**RESPONSE TO COUNTY OF VENTURA GEOLOGY PORTION OF
THE INCOMPLETENESS LETTER DATED APRIL 22, 2022
PROPOSED CABINS AND WELCOME CENTER**

Brandeis-Bardin Campus,
Simi Valley, California

July 12, 2022 W.O. 7588

Subject: Response to County of Ventura Geology Portion of the Incompleteness Letter dated April 22, 2022, Proposed Cabins and Welcome Center, Brandeis-Bardin Campus, Simi Valley, California

FIGURE 1

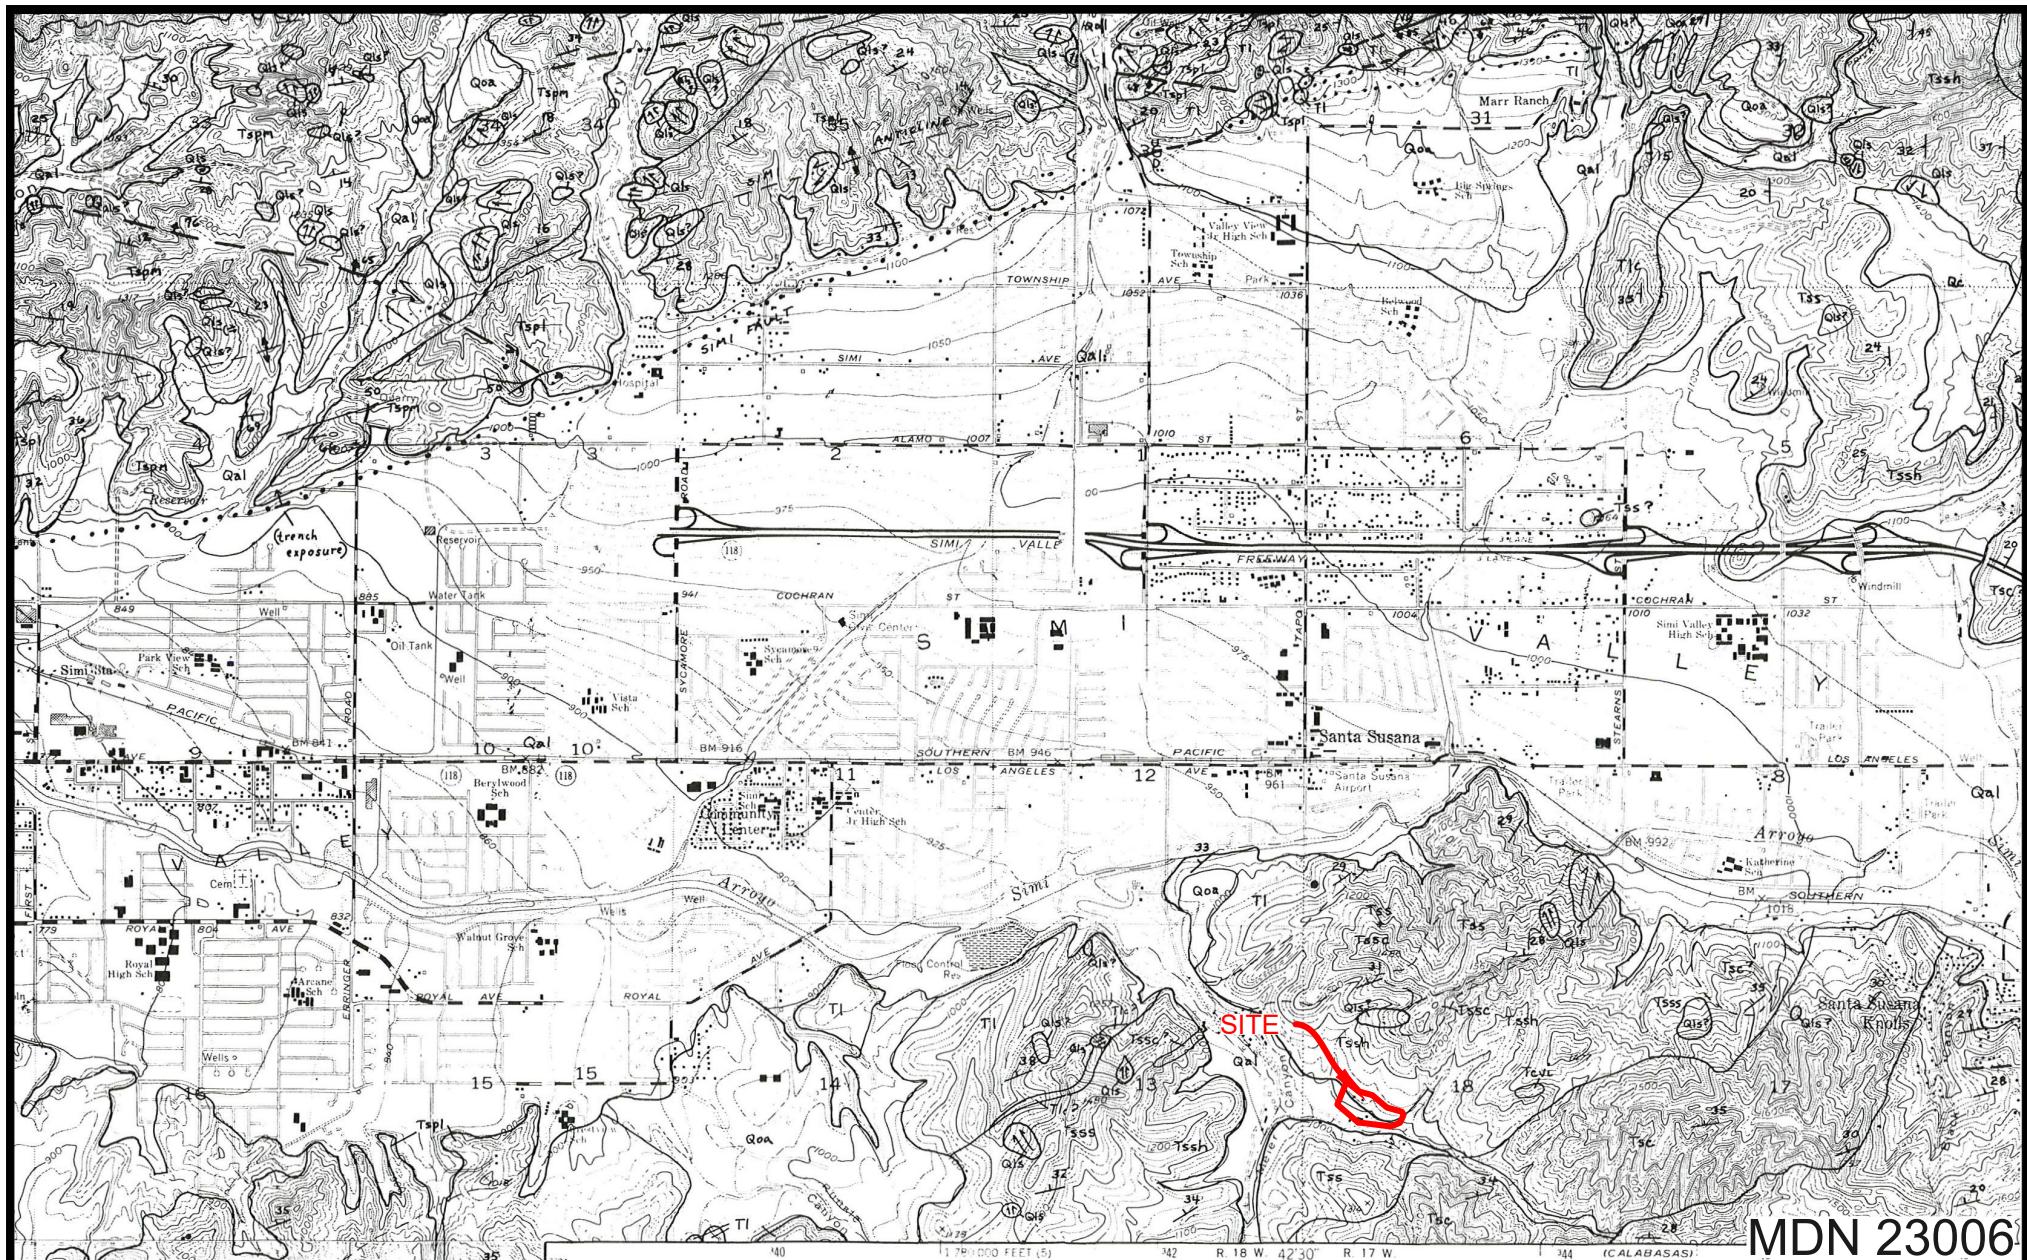
Please provide geologic evaluation for the eastern ascending slope. A landslide is mapped (refer Plate 5, Preliminary Report 14) and landslide geomorphology appears present. Provide justification why the slopes are not considered to represent a landslide hazard (page 8).

GSC has reviewed the referenced reports, Seismic Hazard Zone maps, and performed additional field mapping. As shown on Figure 1, a questionable landslide is mapped in a tributary canyon to the northeast of the subject site. The landslide appears to have failed in a northern direction and away from the site. The toe of the landslide is approximately 600

feet away of the area of proposed development. A photograph of the mapped landslide is included (Photo 7) and the toe of slide is separated from the site by a natural drainage channel at a gradient of approximately 4:1 to 5:1. In addition, any possible debris from the slide in the event of mobilization would be directed into the natural drainage channel north of the site. Therefore, the mapped landslide is not considered to be a hazard to the site. The natural slopes adjacent to the site are generally less than a 4:1 gradient and are not subject to landslides.

Plate: C-1

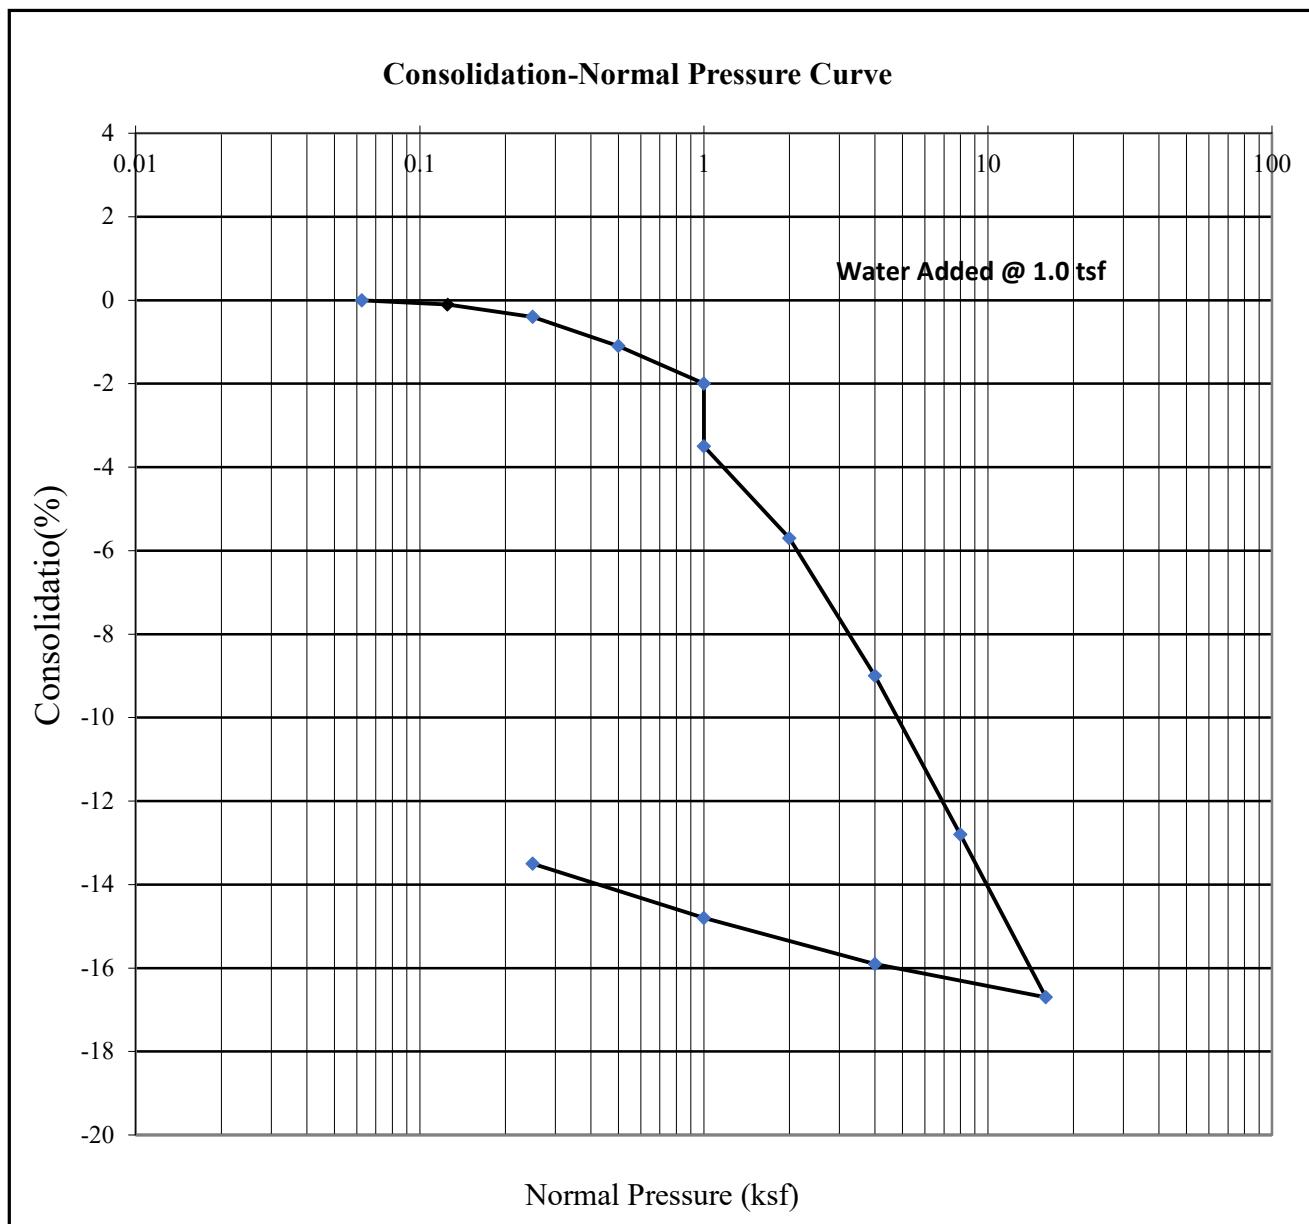
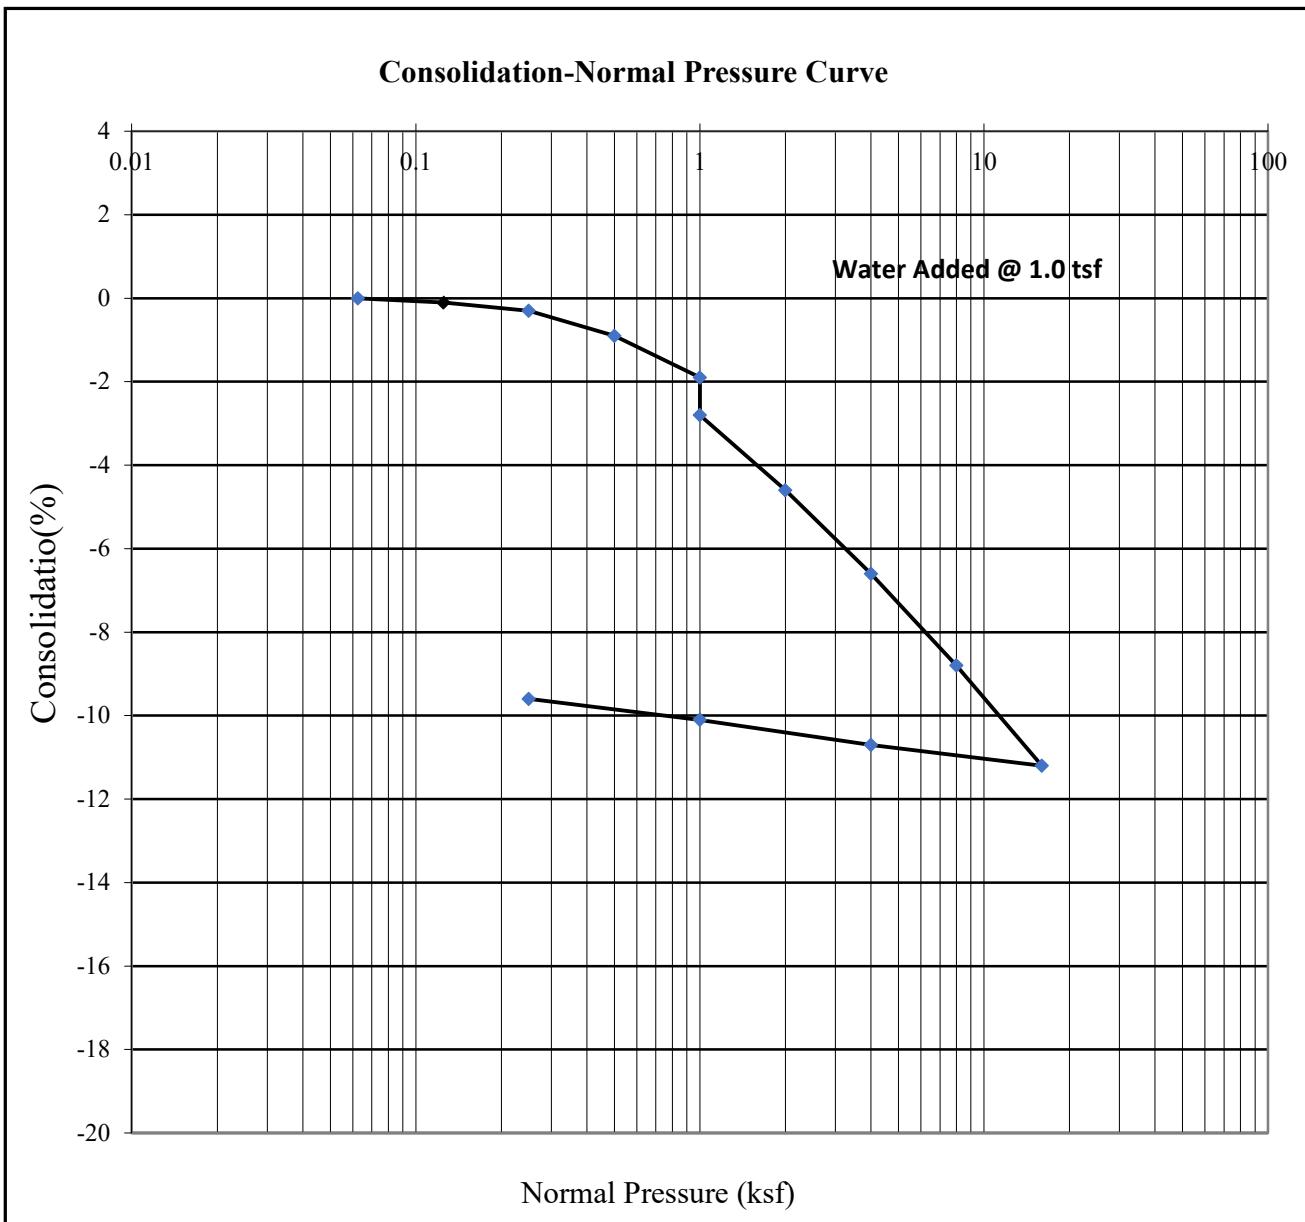
Please explain how a single consolidation test is representative for the entire site with regards to potential consolidation.

As stated in Response to Comment 1, the terrace deposits consist of abundant gravel, cobble, and small boulders. Additional borings were excavated in the proposed Welcome Center area and encountered refusal at shallow depths due to abundant cobbles. Additional laboratory tests were performed on samples from the borings and are included in Appendix A. Photo 1 shows the cut slope behind the existing structure in the area of the proposed Welcome Center. Photos 2 through 5 show additional areas of exposed cobbles

on the site. Based upon our additional field and laboratory testing, the recommended removals presented in the referenced report remain adequate.
